UNITED STATES PATENT AND TRADEMARK OFFICE

APPLICATION NO.	FILING DATE	FIRST NAMED INVENTOR	ATTORNEY DOCKET NO.	CONFIRMATION NO.
10/501,705	07/16/2004	Jin-Young Park	ASIAP123	5119
25920	7590	02/06/2006	EXAMINER	
MARTINE PENILLA & GENCARELLA, LLP 710 LAKEWAY DRIVE SUITE 200 SUNNYVALE, CA 94085			MAKI, STEVEN D	
			ART UNIT	PAPER NUMBER
			1733

Office Action Summary

FIG. 3

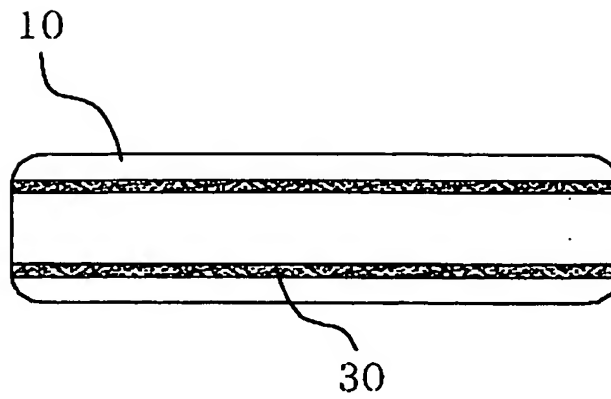
1) The substitute specification filed 7-16-04 has been entered since applicant provided the clean copy, marked up copy and statement of no new matter. In order to expedite prosecution, the drawing sheet containing figures 3 and 4 have been entered since the subject matter of figure 3 is reasonably conveyed by the original disclosure.

FIG. 4

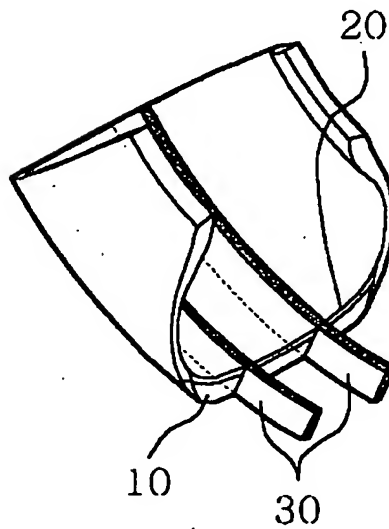
(2) New Figure 4.

New Figure 4 filed 7-16-04 illustrates specific construction of the tire. In particular, new figure 4 illustrates bead regions of the tire and appears to illustrate the electric discharge passages 30 as extending to the inner surface of the tire which defines the inflation chamber of the tire. The above noted subject matter in new figure 4 is not supported by the original disclosure.

Applicant is required to cancel the new matter in the reply to this Office Action.
